Colliford Dam sand waste embankment and asphaltic concrete membrane

T. A. Johnston and J. D. Evans

DISCUSSION

Fig. 13. Deflexion measurements during impounding at Windscar

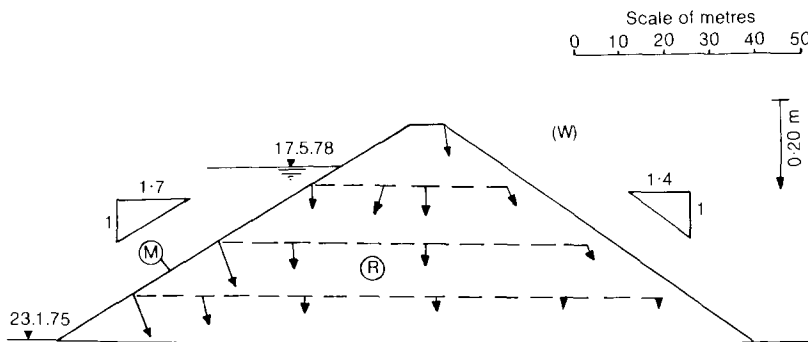
84. Windscar was one of the first of these dams. The deformation of the membrane when the reservoir was filled could be measured by horizontal plate gauges which were fitted through the dam at three positions. The deflexion measurements made during impounding are given by the vectors shown on Fig. 13. This instrumentation does not reveal the differential movement that can take place at the plinth. Measurements were made on Marchlyn Dam which was one of the other few British dams to use an upstream asphaltic membrane. For this exercise a trolley was devised which would run on a railway line that was fitted on the face of the asphalt. It ran underwater so that the deflexion that occurred on filling the reservoir could be measured. A description of the measuring trolley has been given by Penman and Hussain.¹⁴

112. The Authors were interested in *Dr Penman's* settlement information from Winscar and Marchlyn dams. It appears that the measured settlement at Marchlyn of about 20 mm was about one-tenth of the pre-construction estimate. The Authors' experience at Colliford has been similar. The monitoring equipment is much less extensive but the available results suggest that actual settlement under the membrane has been much less than allowed for. This is a satisfactory situation and may well reflect the higher standards of compaction which contractors can now achieve.

Fig. 14. Membrane deflexion at Marchlyn Dam

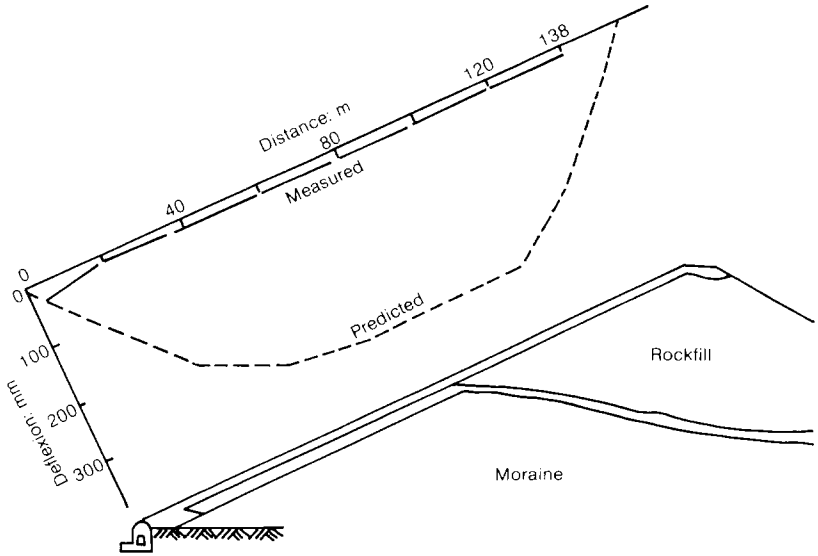
85. The designers of the dam had made various assumptions and predicted a total deformation of the upstream slope during and subsequent to construction with a maximum of about 250 mm near the middle. The measured movements of the membrane were much less than this, as shown by Fig. 14 the maximum being only about 20 mm in the central part of the membrane. Near the toe, adjacent to the concrete cut-off structure, there was a differential movement of 25 mm, shown by Fig. 15. The beauty of the trolley mechanism was that it shows the movement that can occur between the rigid concrete structure, which is both founded in bedrock and standing on top of the grout curtain, and the asphaltic membrane, which is supported by the fill. As in the case of bridge abutments, the fill is very difficult to compact tight up to a concrete structure with a vertical wall, so in this zone it may be slightly less dense or well compacted than the rest, and this leads to some differential settlement. Special arrangements had been made to allow for more movement at this point, so 25 mm did no harm. However, it shows that there can be larger movements immediately adjacent to the concrete structure. At the bottom of Colliford Dam (Fig. 8 of the Paper) the Authors have wisely made a sloping back to their concrete cut-off to simplify the completion of the sand fill. Could they explain more about that? They have also provided for extra reinforcement of the membrane to allow for differential movement that might occur.

Fig. 16. Colliford—compaction curves and saturation lines

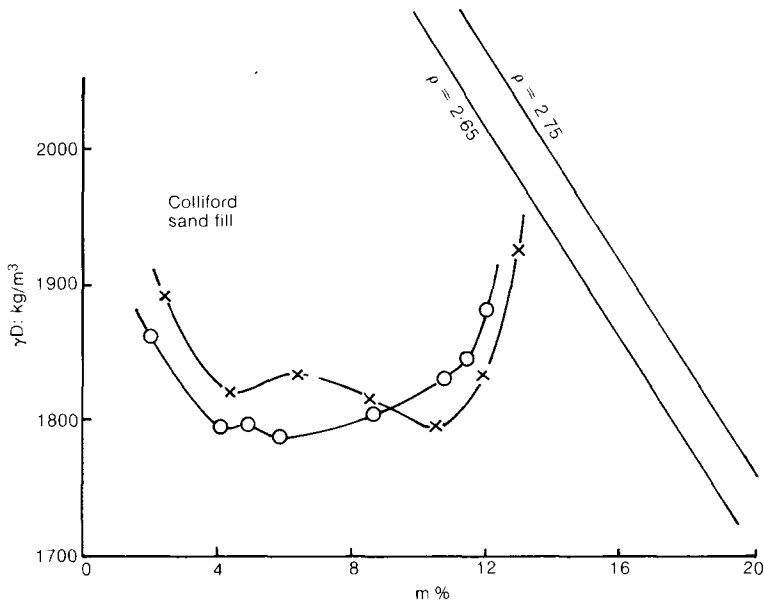
87. Concerning the problems of compaction of the sand, the Authors showed the upside down sort of compaction curve that develops with sand, but omitted the saturation lines. I have put on saturation lines for specific gravities of the sand of 2.75 and 2.65 in Fig. 16. It is very difficult to imagine such a curve turning over in time to meet the 2.65 line. Perhaps the figures here are wrong. Could the Authors explain this problem?

113. *Dr Penman and Mr Smith* have drawn similar graphs, Figs. 16 and 17. The specific gravity of the sand fill is 2.66 and no doubt if the fill had been well graded and included particles of clay and silt size the saturation lines on the graphs would have been useful in assessing compaction. However, the concept of a saturation line is not really helpful with uniform materials such as at Colliford. The size and shape of the particles in the fill dictate the matrix of the fill. Point-to-point contact of the fill material, and hence the same dry density, can be achieved over a reasonable wide range of moisture contents.

Fig. 17. Compaction curves for embankment sand—Balanga and Colliford

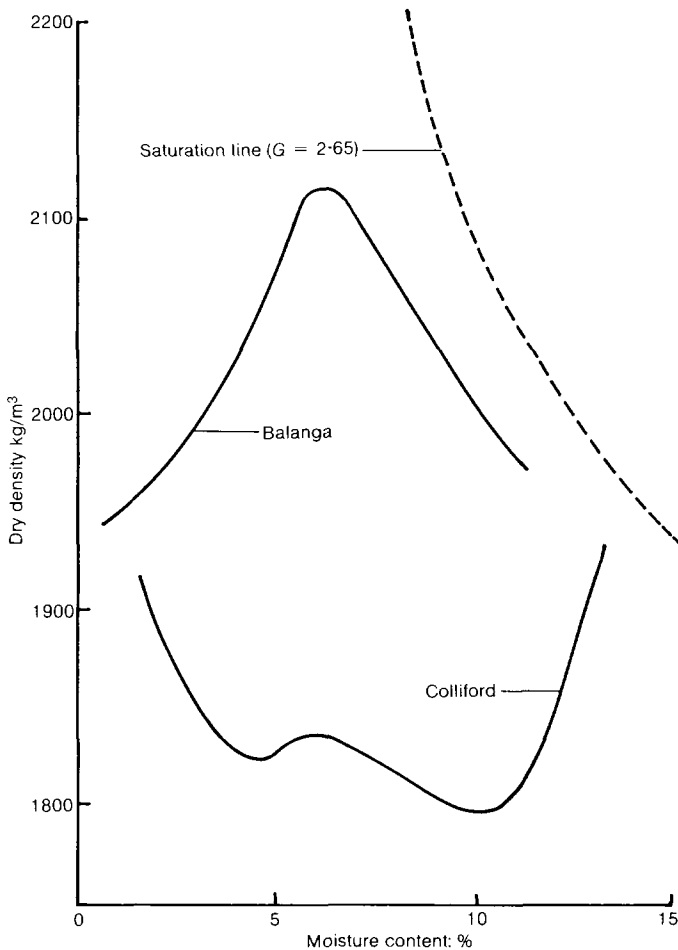
The fill, as the Authors point out, is rather unusual with an inverted W or U density curve (as in Fig. 17) but it is perhaps not so unusual to people used to working in desert climates. Desert sands and desert fills frequently have this sort of curve which seems typical for the more or less uniform graded material that occurs. The uniformity of that grading probably also leads to the fairly low densities of these sands. The influence of adding a little silt to the material drastically changes that behaviour.

91. There is a great difference in both the density and the shape of the curve. This is probably caused only by the silt content. A further point is that the curve for Colliford sand is close to and tending to cross the 100% saturation line at high moisture content. The 100% saturation line has been plotted assuming a specific gravity of 2.65. Could the Authors comment on these points in the light of any other investigations that they made on other materials? At Balanga the fines made the material very easy to handle. Although very similar compaction plant was used, that is a large smooth-drum vibrating roller of about the same weight as at Colliford, only about four passes were needed to get the maximum density, provided the considerable volume of water needed was added.
